Subject Shear Walls and Diaphragms with Staples as Fasteners

Dear Committee Members and Correspondents:

Subject: Shear Walls and Diaphragms with Staples as Fasteners

FIGURE B4

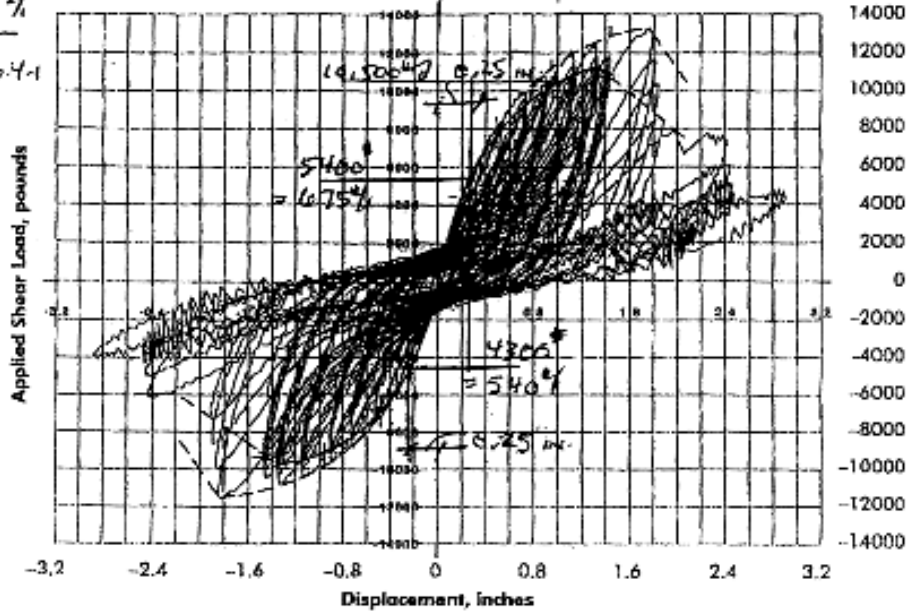
$\Delta = 1.9 \text{ in.} = C_d: 4 \times 0.25 \text{ in.} = 1.0 \text{ in. FOR } R=6$
 $= 10,500^* = 1300\% \div 3 \times \Omega_0 = 440\%$

$\frac{440\%}{550\%} = 80\%$

Typical hold-down load vs. shear wall load (Test BLS.1A)

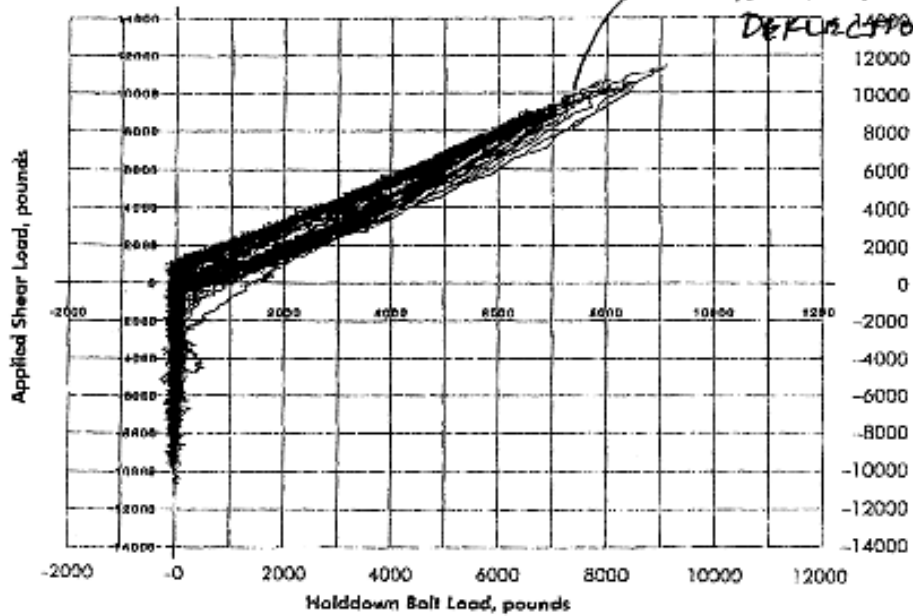
WE NOW HAVE
HOLD-DOWNS w/ 1/8
DEFLECTION AT 10,000
LBS

Photo 1:
View of 16 ga. stapled shear wall after test showing plywood loose at top and bottom with staples sheared at surface between back of plywood and face of studs.

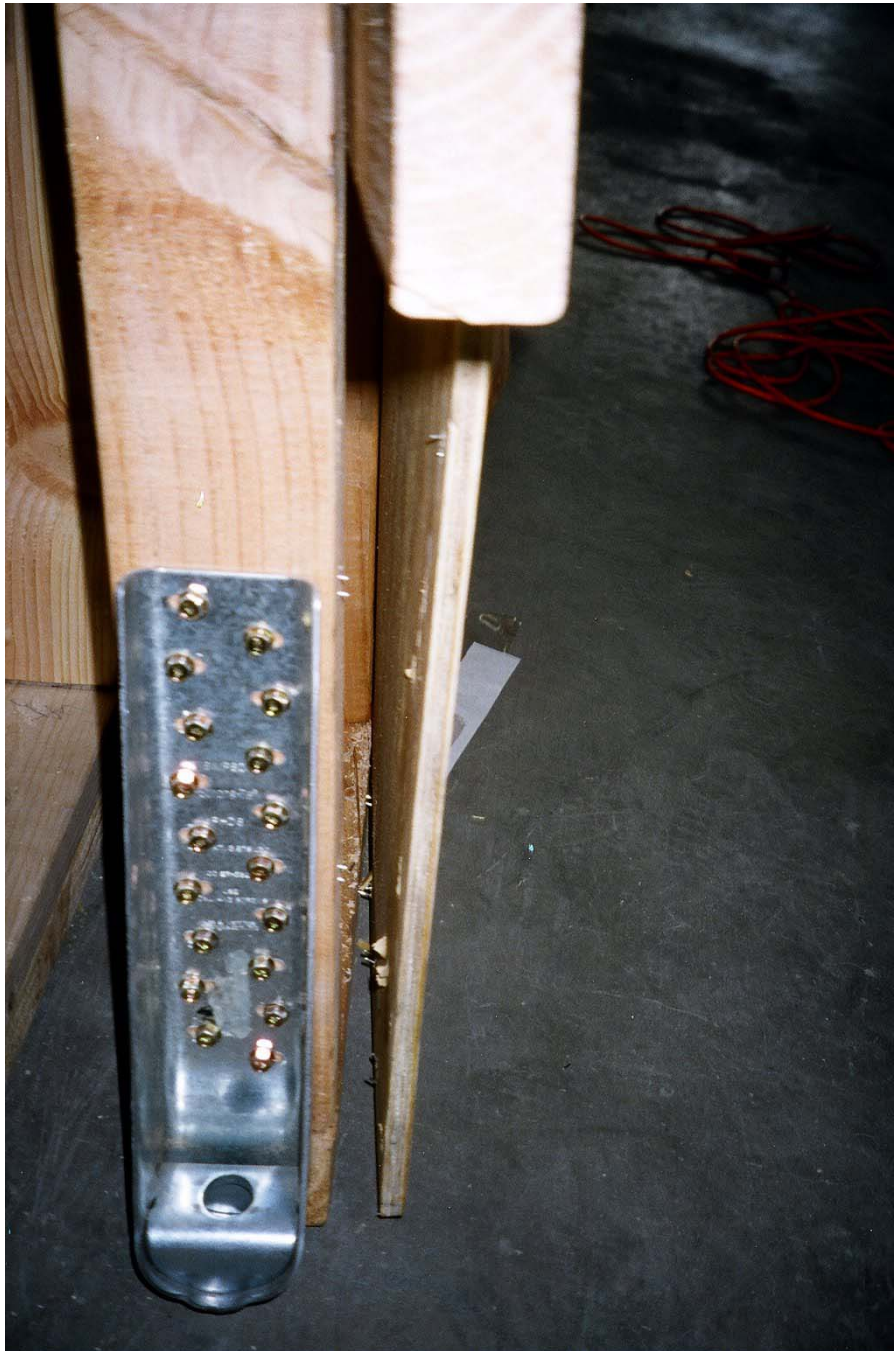
Photo 2:
View of left corner at Hold-Down with staples sheared flush with end-post. Staples at adjacent stud still holding panel to wood frame. Total of approximately 30 out of 224 staples held panels to frame.

Photo 3:
View of right edge of right panel, removed to show back side, with 8 staples that were still attached to the frame. No other staple legs were visible.

Photo 4:
View of stud with staple legs sheared after flexing to form a $\frac{3}{4}$ inch slot. The adjacent panel shows $\frac{7}{16}$ inch staple crowns at 3 inches on center with no visible sign of distress.

Four photos (included as attachments) taken October 1, 2007 after removing the plywood from the frame show the typical shearing of the staple legs while the crown is unaffected.
